TO: Mercedes-Benz Dealer Principals, General Managers, Sales Managers, Service Managers, Parts Managers	FROM: Thomas Brunner, Department Manager, Vehicle Compliance and Analysis, Engineering Services
RE: <b>Recall Campaign 201502003-Retrofit Headlamp Adjustment Screw Caps. Model 205 (C-Class Sedan) Model Year 2015</b>	DATE: May 6, 2016

Campaign No. 2015020003, May 2016

SUBJECT: **Model 205 (C-Class), Model Year 2015**  
**Retrofit Headlamp Adjustment Screw Caps**

Figure 1

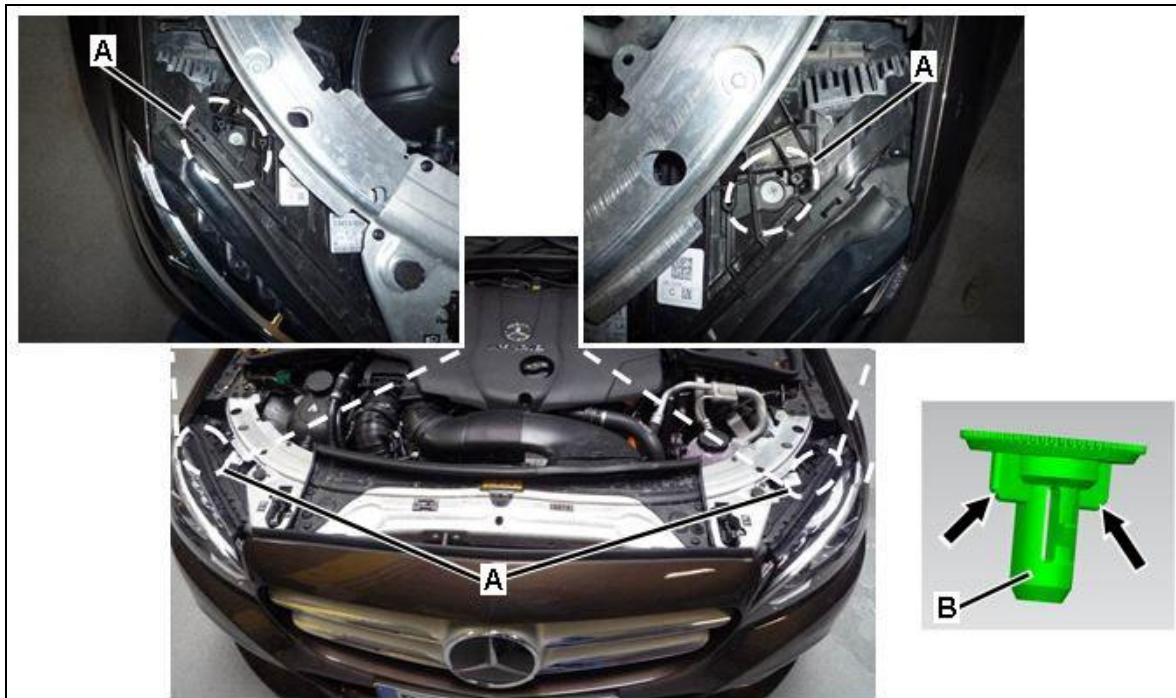
Daimler AG (DAG), the manufacturer of Mercedes-Benz vehicles, has determined that the headlamps might not meet the requirements of Federal Motor Vehicle Safety Standard (FMVSS) 108, which requires that headlamps with low beams must not have a horizontal adjustment mechanism. The subject vehicles are designed to meet this requirement by sealing off the headlamp horizontal adjustment screw with a non-removable sealing cap after initial adjustment in the manufacturing plant. The sealing cap may not have been installed on these vehicles. An authorized Mercedes-Benz dealer will retrofit the two sealing caps.

1. Open hood.
2. Retrofit cap (B, Figure 1) for headlamp adjustment screws (A) at left and right:
  - Position cap (B, Figure 1) on headlamp adjuster (A) so that the tabs (arrows) on the cap (B) align with the grooves in the adjuster (A).
  - Press the cap (B) into adjuster (A) by hand until it locks into position.

An audible click will be heard when the cap (B) is properly seated into the adjuster (A).
